Service Bulletin

No. : MZ09-042
Date: August 27, 2009

Model: SR8002/7002

Subject: Change of supplied Remote Controller
* This Service Bulletin is only service information for the following minor improvement. This is <u>not</u> a call requiring a rework to be applied to stock units.

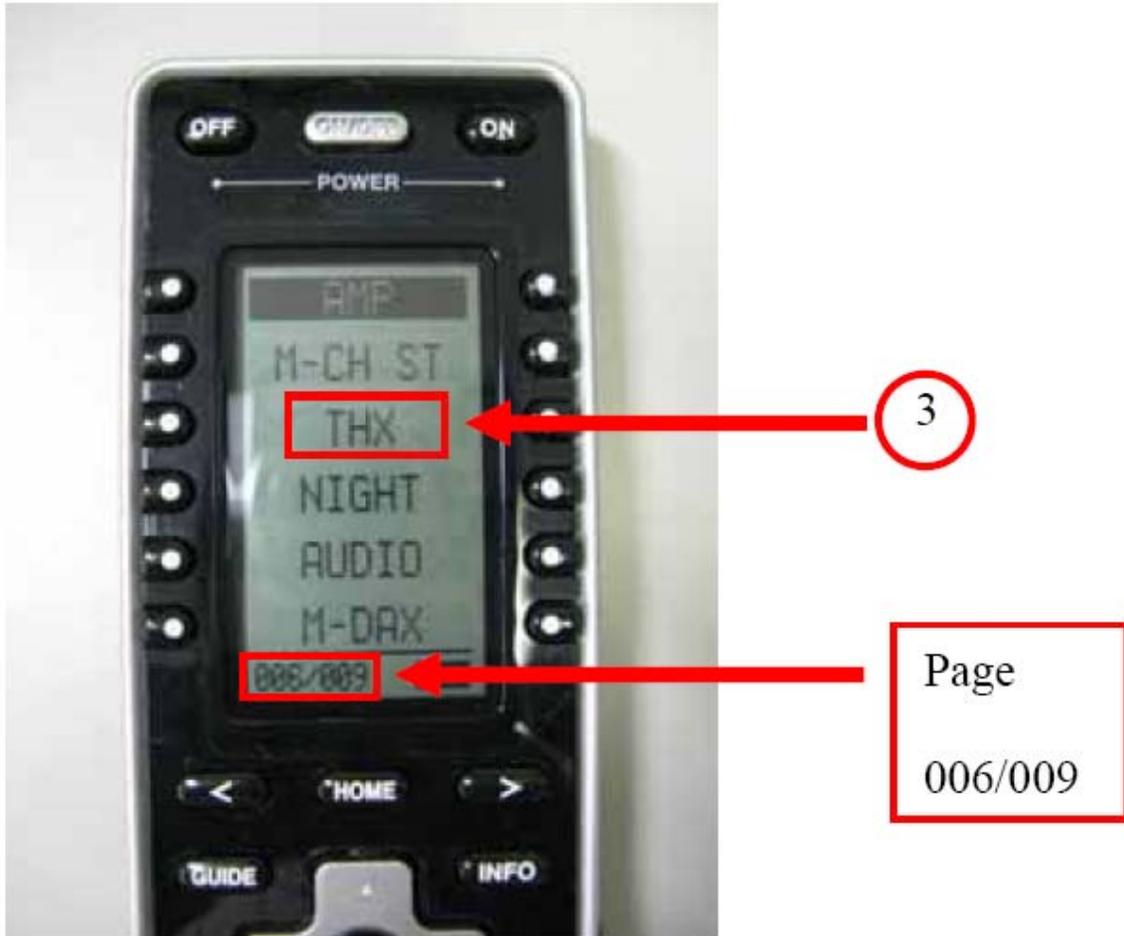
3. Please confirm that the Programmable soft button will be assigning the "THX". (The Programmable soft button will be assigning the "RE-EQ" if the firmware of RC3001 is not updating.)
